Three Mile Island Nuclear Station Unit No. 1
Docket Number 50-289

Errata Sheet to responses to questions raised in Enclosure 2
of the NRC's 2-18-76 letter to TMI-1 concerning Appendix I

RESPONSES TO QUESTIONS RAISED IN ENCLOSURE 2

CONCERNING APPENDIX I

FIGURE 8-4

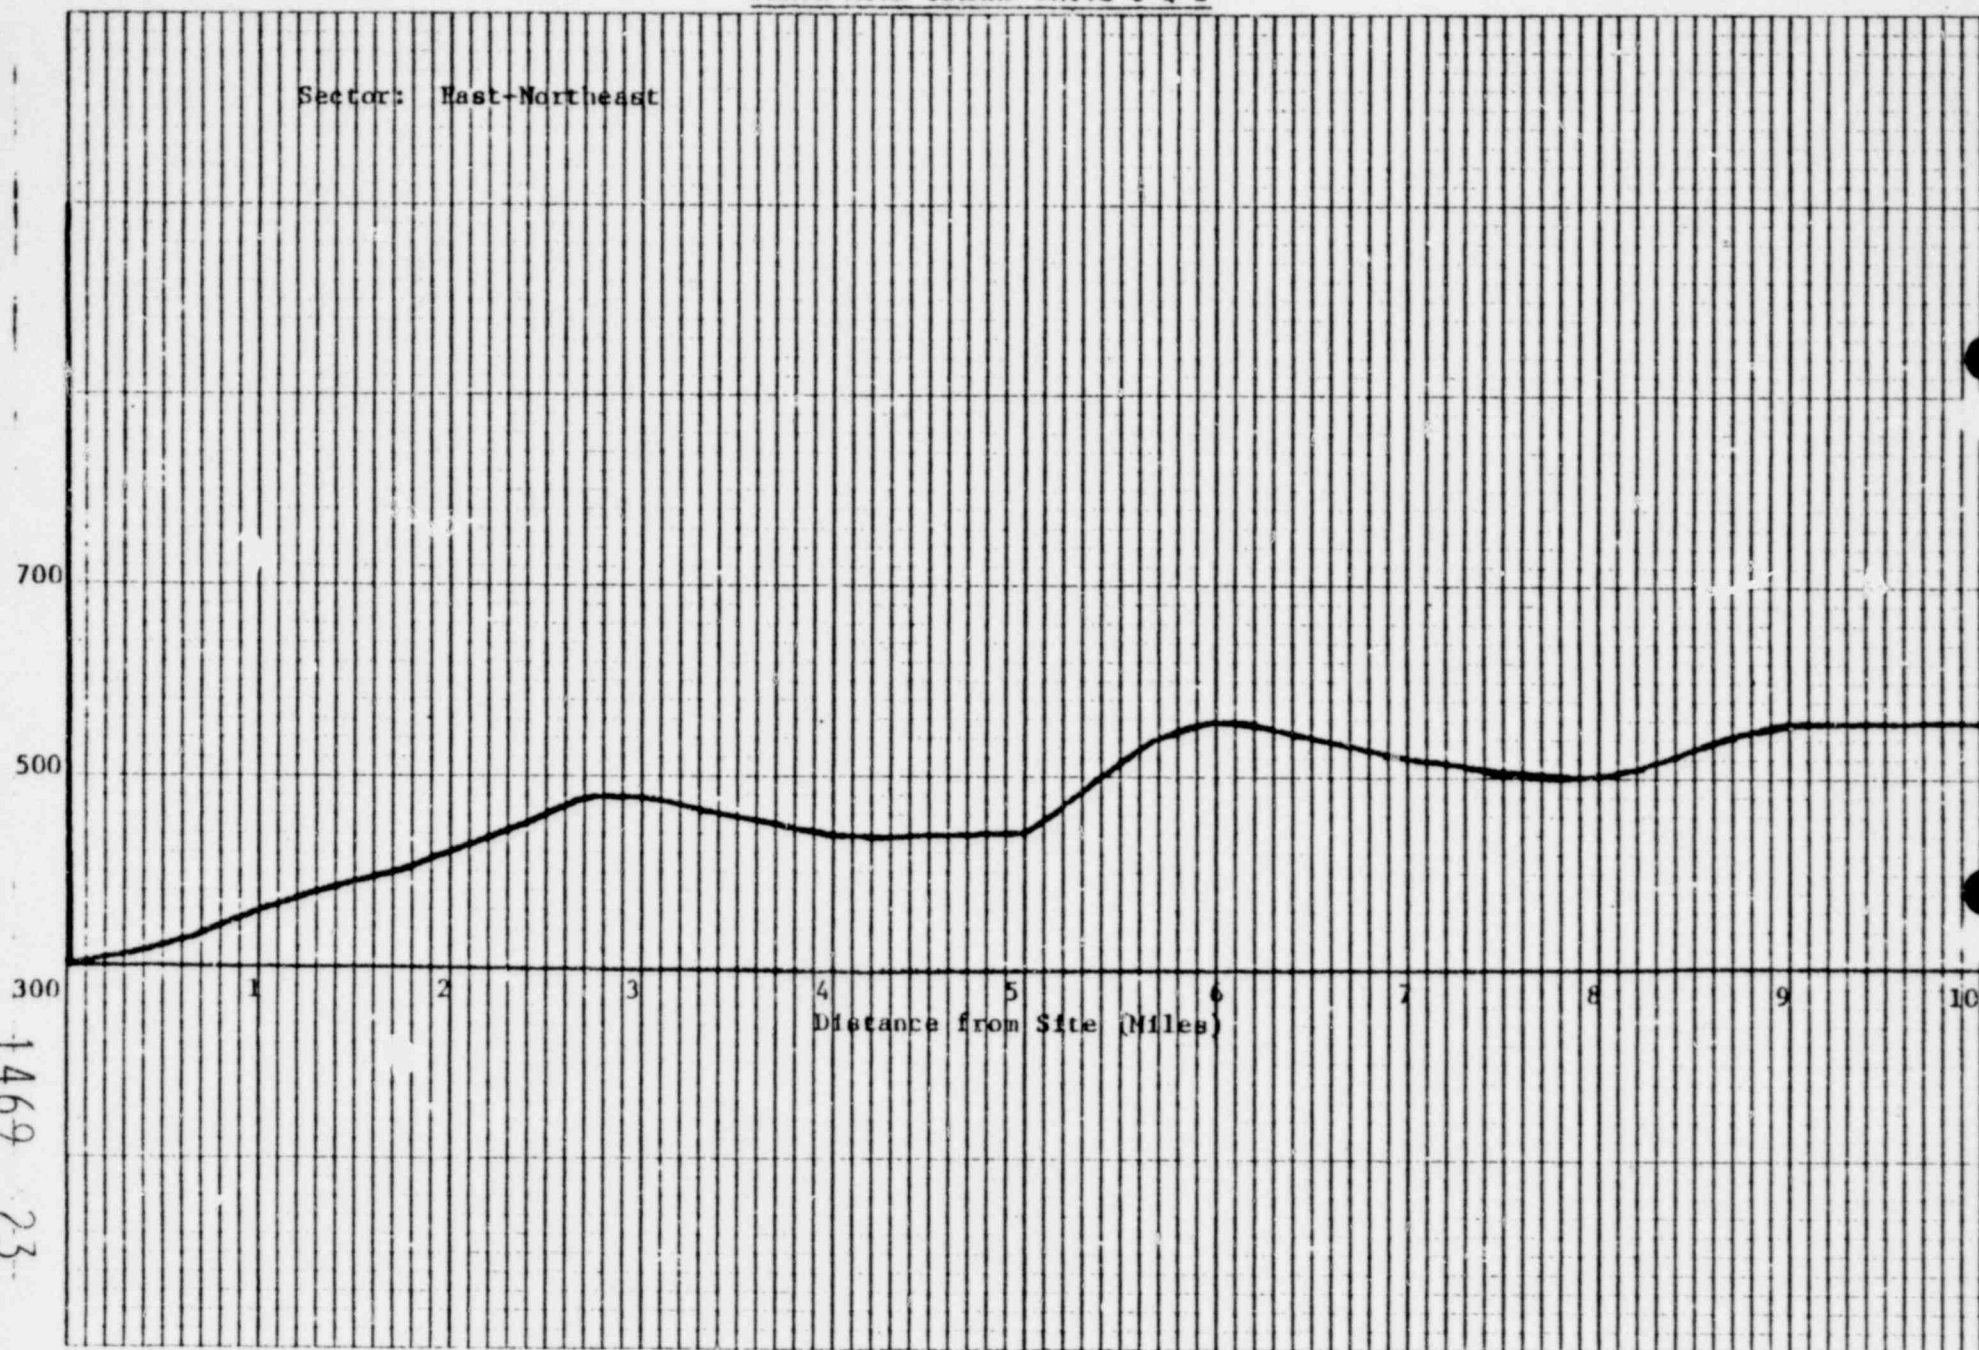
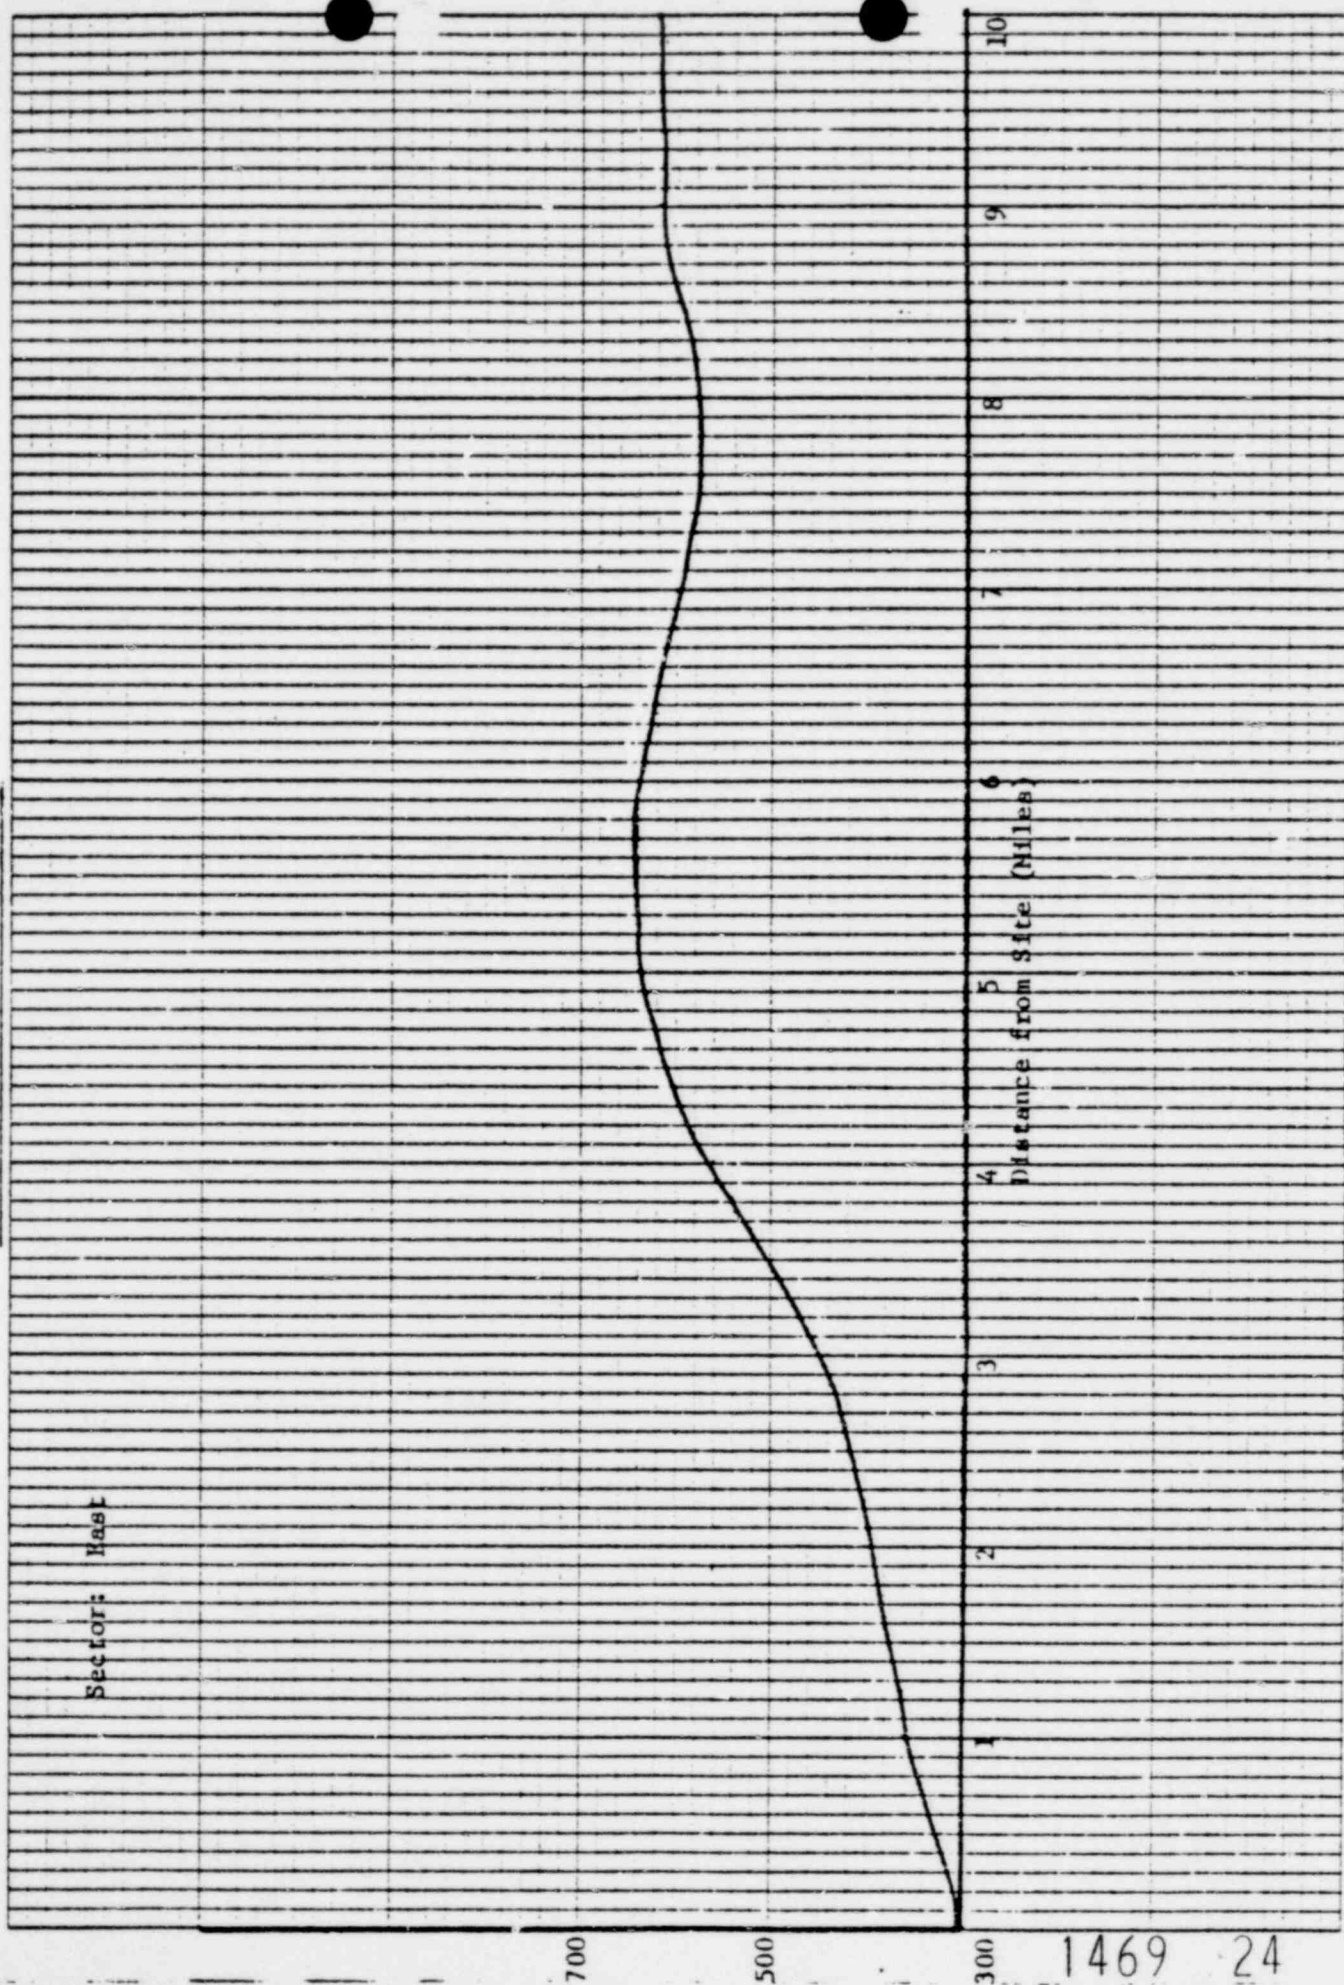
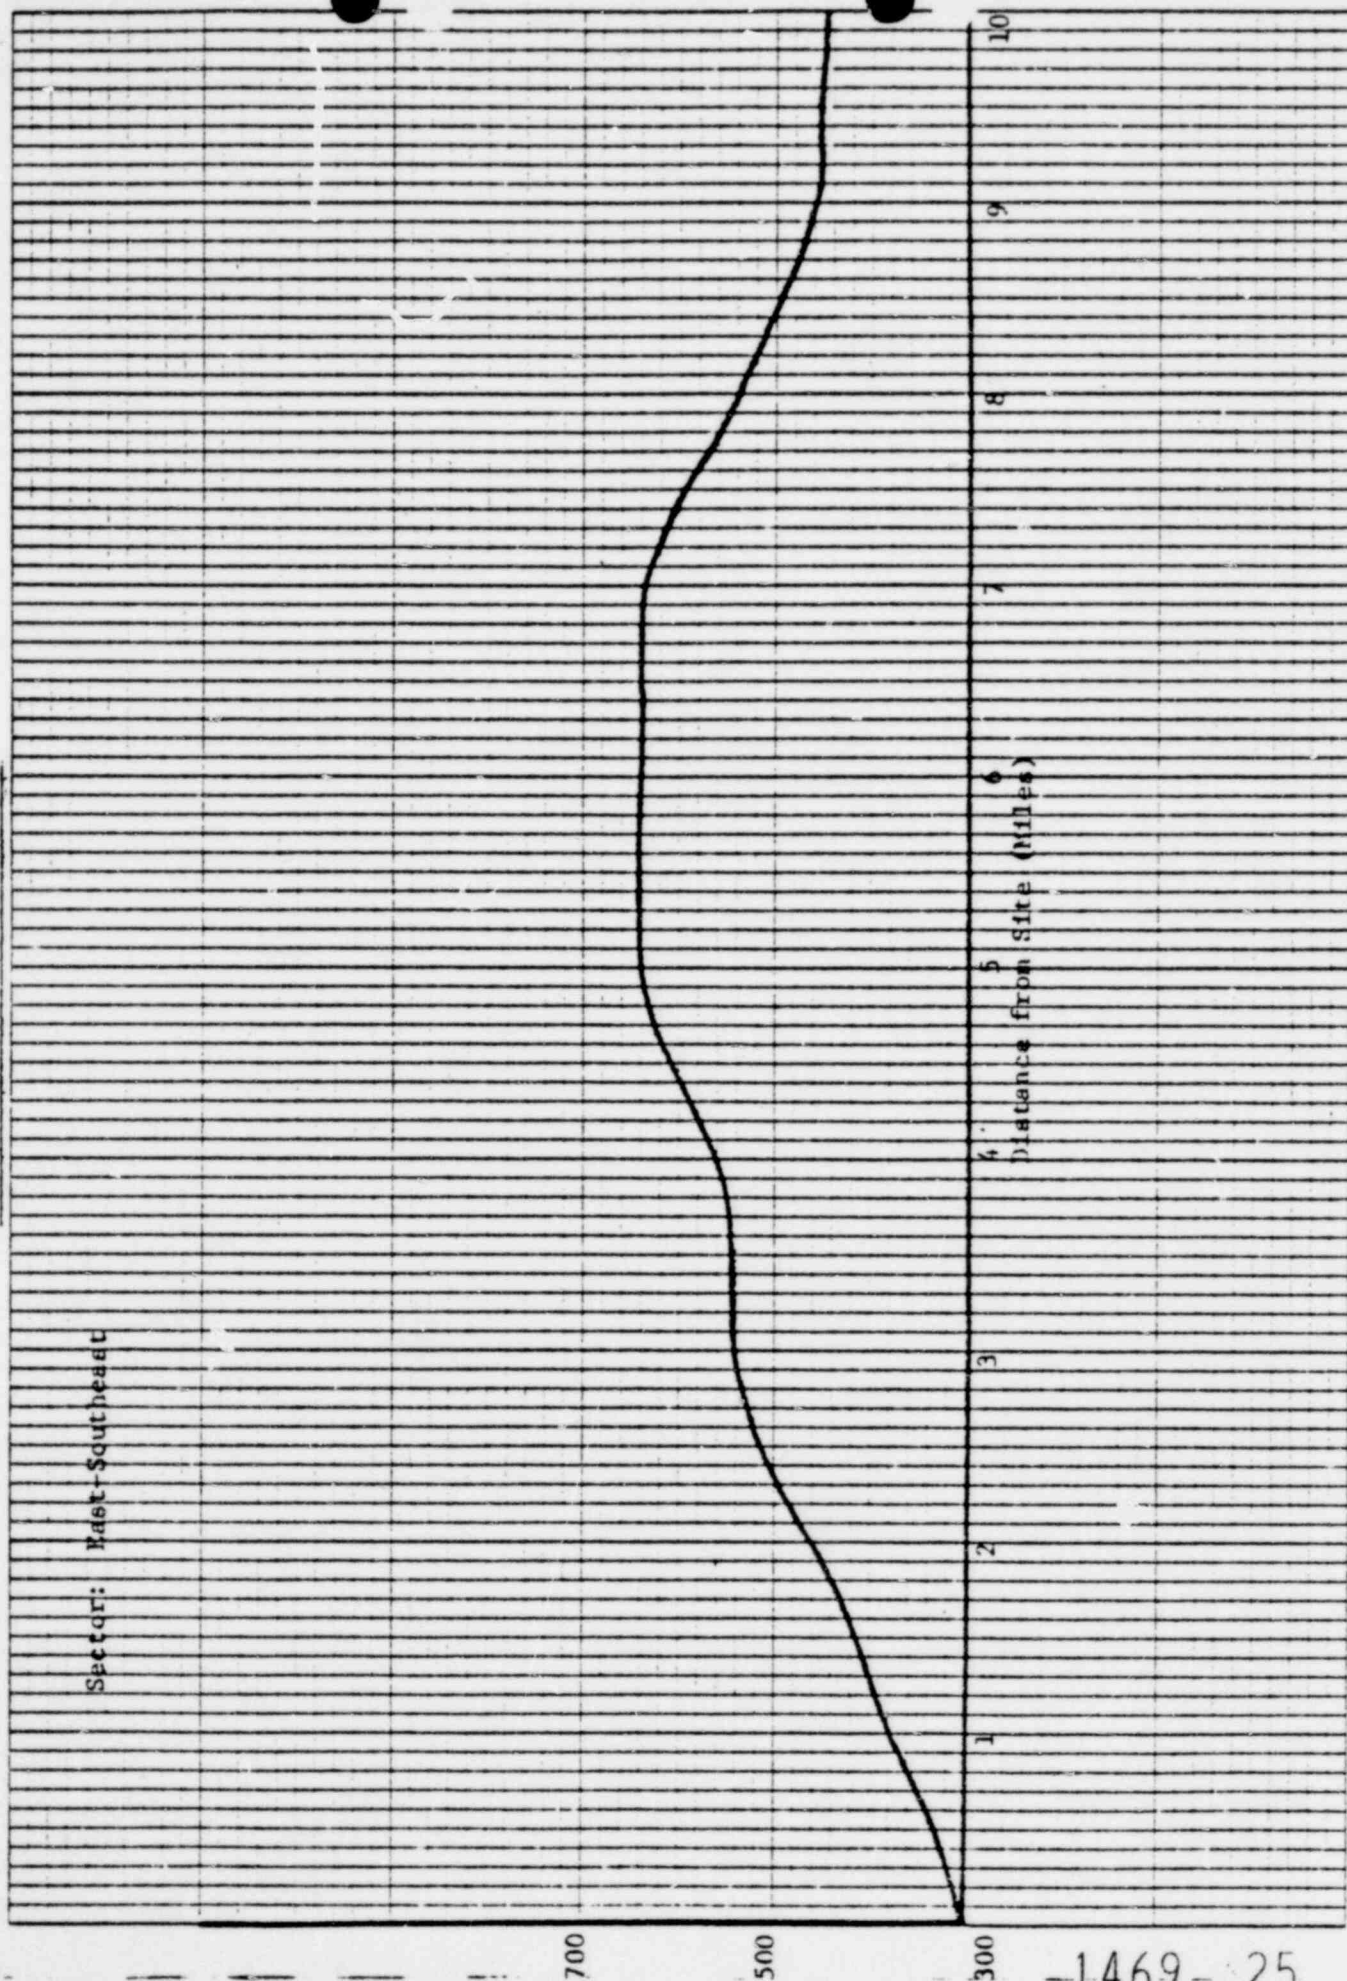
Provide a map showing the detailed topographical features (as modified by the plant) on a large scale, within a 10-mile radius of the plant and a plot of the maximum topographic elevation versus distance from the center of the plant in each of the sixteen 22-1/2 degree cardinal compass point sectors (centered on true north), radiating from the center of the plant, to a distance of 10 miles.

RESPONSE

See attached Table 8-1 and Figures 8-1 through 8-16.
